**RE: Legacy 2 Multifamily  
7800 Headline Blvd NE  
Revised Conceptual Grading and Drainage Plan  
Engineer's Stamp Date: 05/21/20  
Hydrology File: D17D107**

Based upon the information provided in your submittal received 05/21/2020, the Revised Conceptual Grading & Drainage Plan is approved for action by the DRB on Site Plan for Building Permit.

**GP01**  
GRADING PLAN

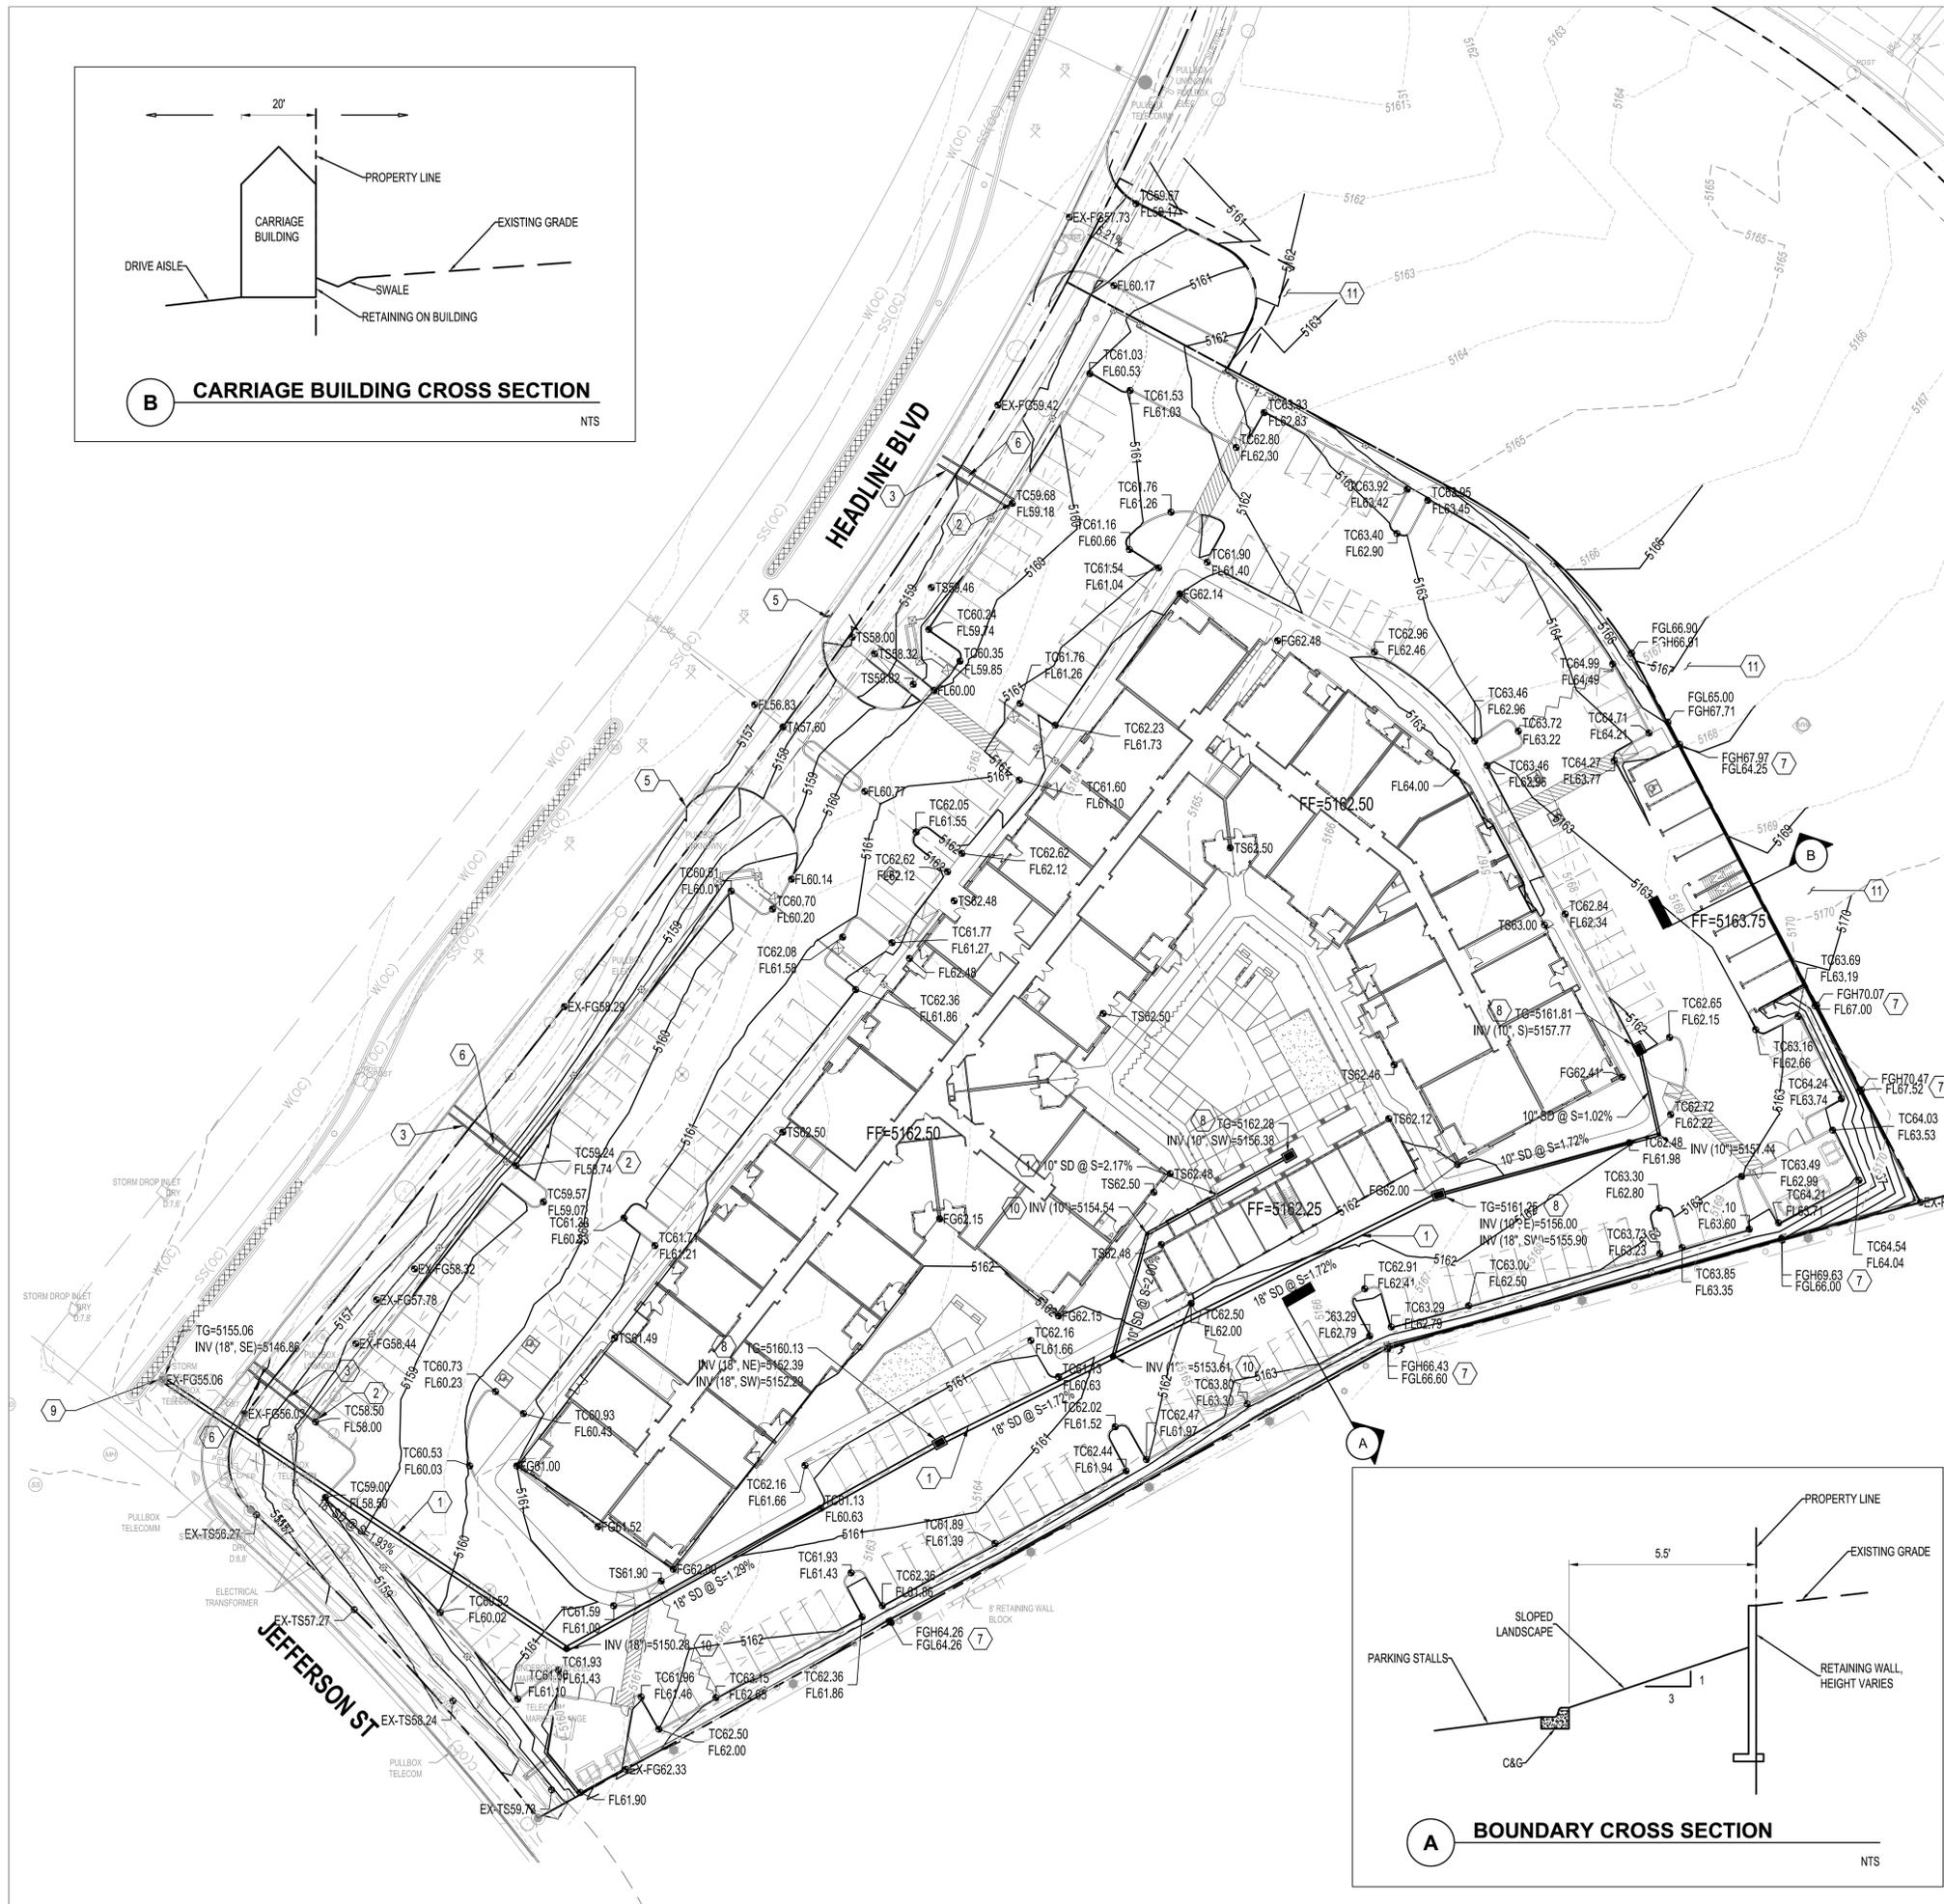
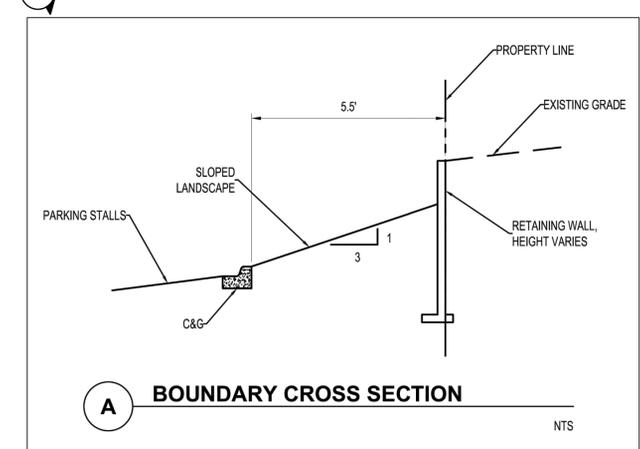
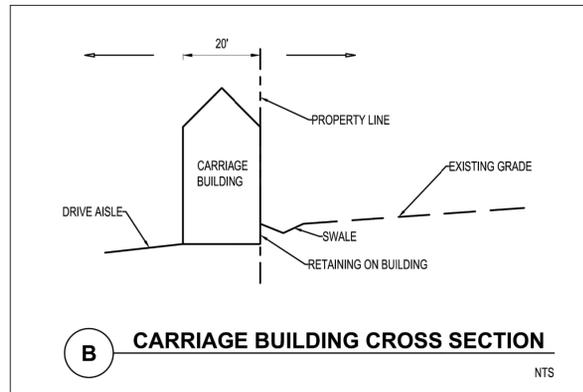
- In accordance with DPM Ch.22, section 5 part B, grading and wall construction near the property line may not endanger adjacent property or constrain its use. If the proposed retaining wall will create such an encroachment, written agreement from both landowners must be provided for such work. Written permission must include: signature of the property owner or owners representative, statement that undersigned is the owner or authorized representative, permission to construct the encroachment with a brief description of the encroachment.
